▶ **FILE #:** 9-B-13-UR

▶ **APPLICANT:** HUBER PROPERTIES / CLEAR WATER PARTNERS, LLC

▶ **PROPOSED USE:** Multi-dwelling development and marina

TRAFFIC IMPACT STUDY
WESTLAND COVE
KNOX COUNTY, TENNESSEE

Figure 11
Recommended Signage Map

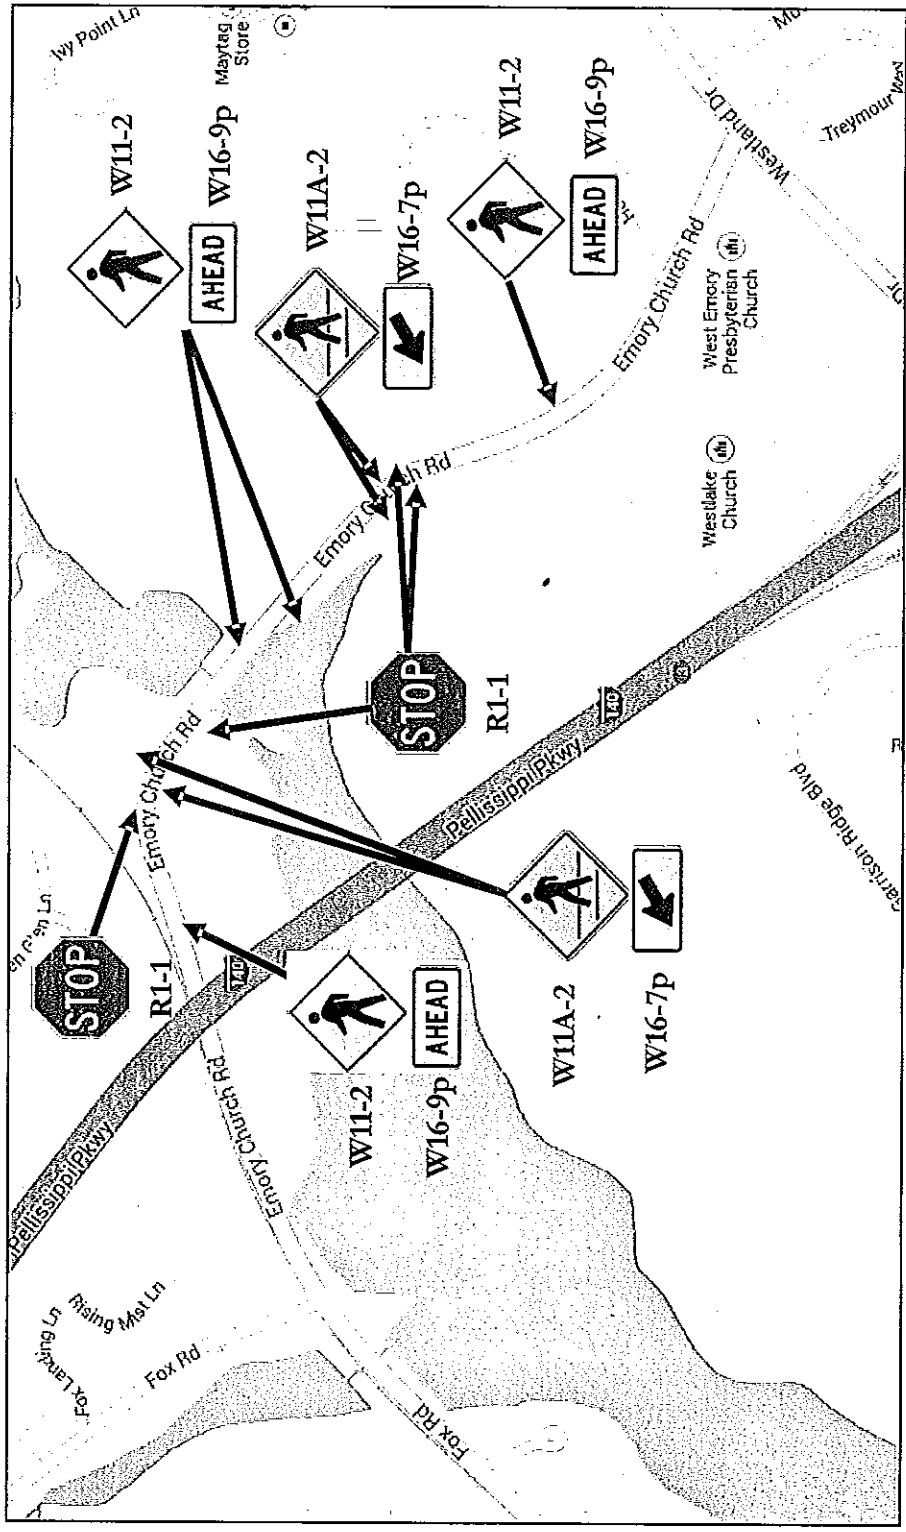
- 2c) Pedestrian in crosswalk signs (W11A-2) with downward arrow plaque (W16-7p) should be installed at each end of the crosswalk location. The signs should be placed in advance of the crosswalk adjacent to the travel lane and facing the driver. Advanced pedestrian warning signs (W11-2) should be installed at a minimum distance of 150 feet but not exceeding 500 feet in advance of the crosswalk in either direction. Advanced warning signs should be accompanied by supplemental plaques with the legend "AHEAD" (W16-9p). See Figure 11 at the end of this report for illustration of recommended signage.
